Z-22
(2009)

KSU/WPS
SOCCER STADIUM
BUSSEE DRIVE & BIG SHANTY ROAD
CORR COUNTY, GEORGIA

SITE PLAN
DATE: APRIL 10, 2009
PROJECT: 09-001
REVISION: C1.0

PETITION NO: Z-22

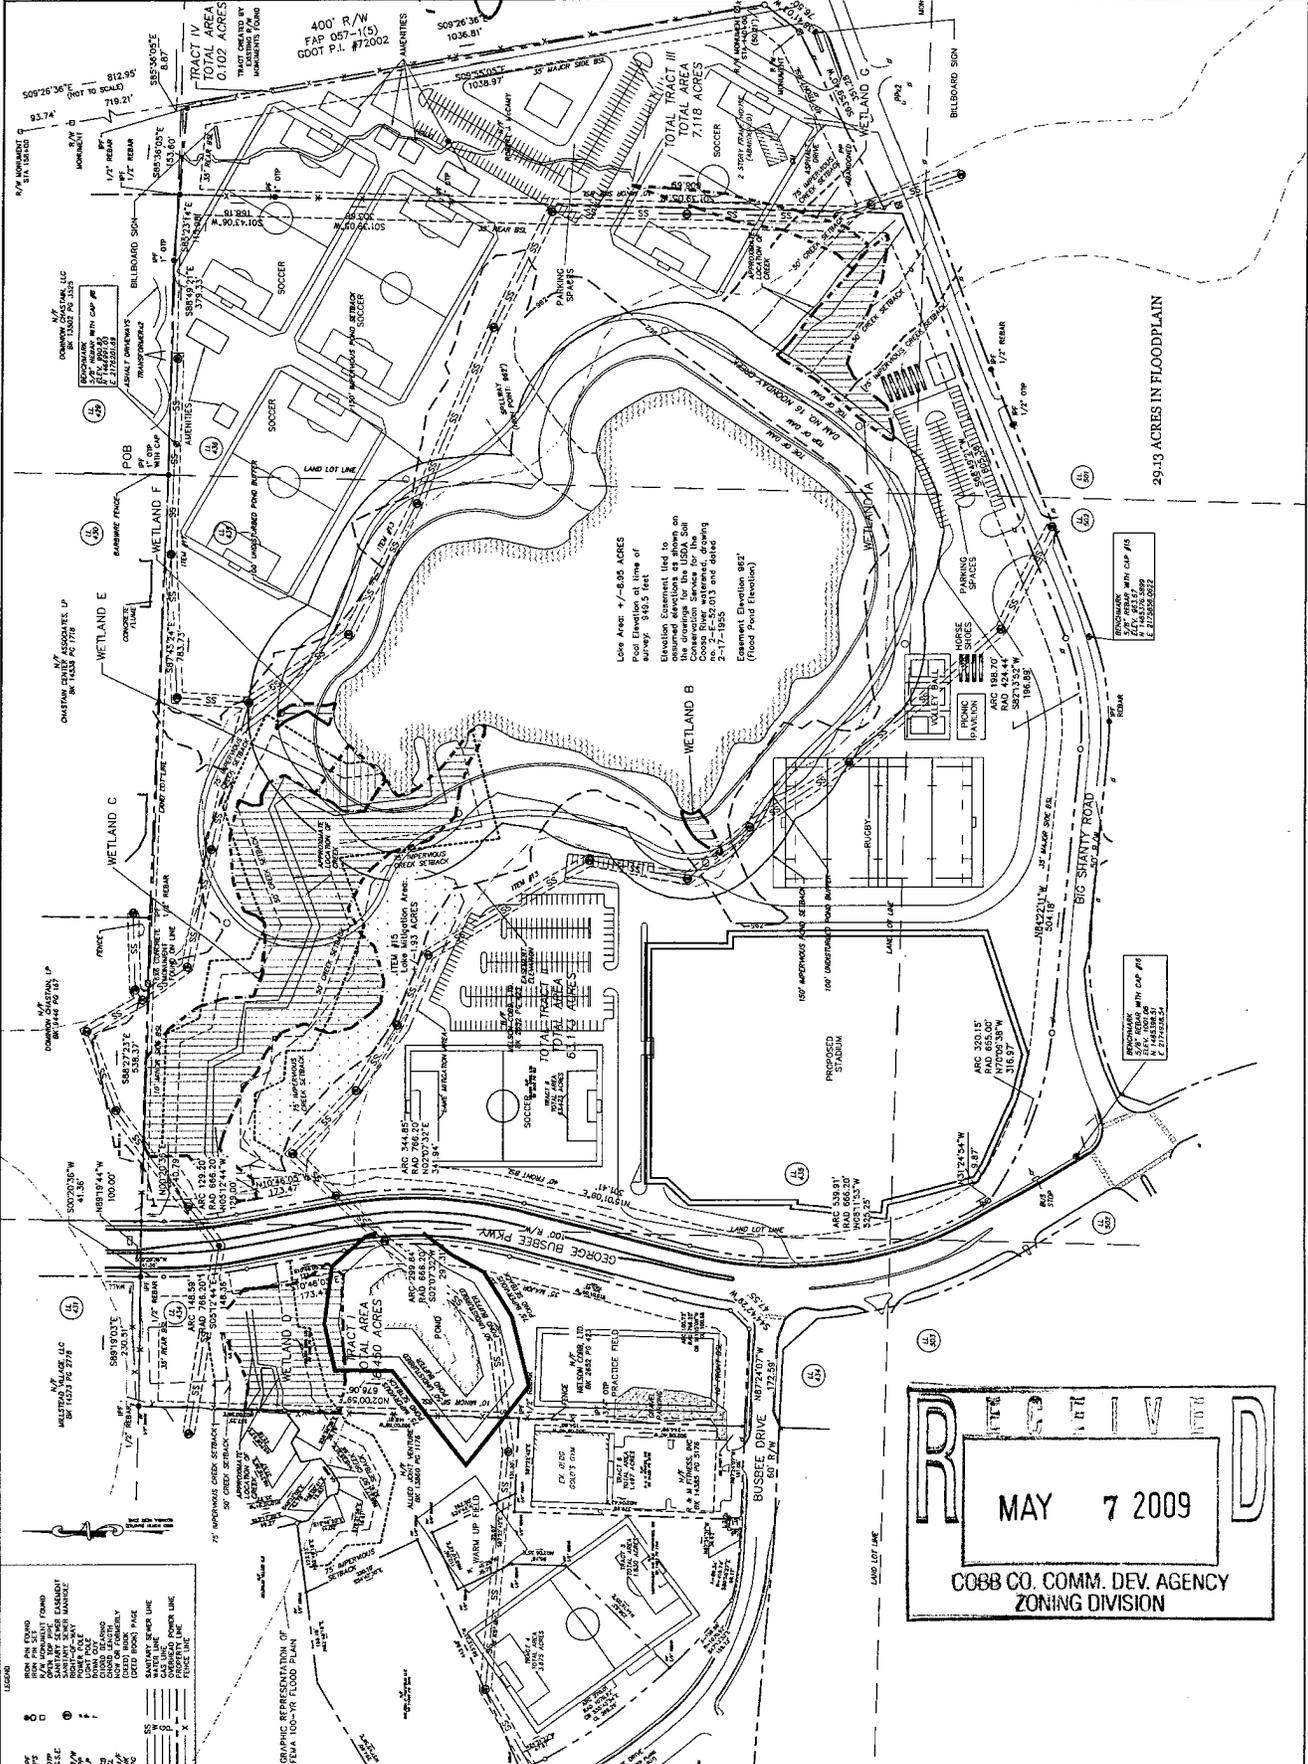
This project must comply with the Cobb County Tree Ordinance. The site plan submitted for zoning review does not show sufficient tree planting islands or peninsulas in the parking lots.

Special protection will be necessary when constructing playing fields and parking over existing CCWS sewer lines. Pipe material upgrade by developer required where improvements close

- FEMA Designated 100 year Floodplain Flood.
- Flood Damage Prevention Ordinance DESIGNATED FLOOD HAZARD.
- Project subject to the Cobb County Flood Damage Prevention Ordinance Requirements.
- Dam Breach zone from (upstream) (**onsite**) lake - need to keep structures out of hazard.

- Provide comprehensive hydrology/stormwater controls to include development of out parcels.
- Submit all proposed site improvements to Plan Review.
- Any **spring activity** uncovered must be addressed by a qualified geotechnical engineer (PE).
- Structural fill _____ must be placed under the direction of a qualified registered Georgia geotechnical engineer (PE).
- Existing facility.
- Project must comply with the Water Quality requirements of the CWA-NPDES-NPS Permit and County Water Quality Ordinance.
- Water Quality/Quantity contributions of the existing lake/pond on site must be continued as baseline conditions into proposed project.
- Calculate and provide % impervious of project site.
- Revisit design; reduce pavement area to reduce runoff and pollution.

1. A significant portion of this property is encumbered by 100-year floodplain as well as the flood storage easement associated with the Noonday Creek Structure #16 Dam. No reduction in flood storage volume can be allowed within these limits. Any grading proposed within the flood zone must be as-built to verify that no decrease in storage has occurred.

2. Noonday Creek Structure #16 is a High Hazard Category 2 Dam that is regulated by the Georgia Safe Dams Program. All proposed site work adjacent to or associated with this dam must be reviewed and approved by the Safe Dams Office. Review by the National Resource Conservation Service (NRCS) and the Georgia Soil and Water Conservation Commission (GSWCC) may also be required.

3. Several improvements are shown within the stream buffer, including the proposed trail, volleyball courts and rugby field. These will need to be relocated outside the undisturbed buffer and impervious setback limits or a buffer variance obtained from Cobb County and Georgia EPD. The proposed trail also crosses an identified wetland area and stream. This crossing must be permitted through Cobb County as well as the Army Corps of Engineers.

4. This lake has already been severely impacted by sediment. The proposed site plan will involve significant grading adjacent to the lake. Additional best management practices must be utilized to protect the lake from further siltation. It is recommended that the onsite trees being cleared from the site be mulched and used to create a temporary filtration berm along the limit of disturbance to provide additional site sediment control. A pre- and post-development sediment survey will be required to document sediment levels in the lake and to verify no development impacts.

Recommend removing the proposed billboard sign from the right-of-way.
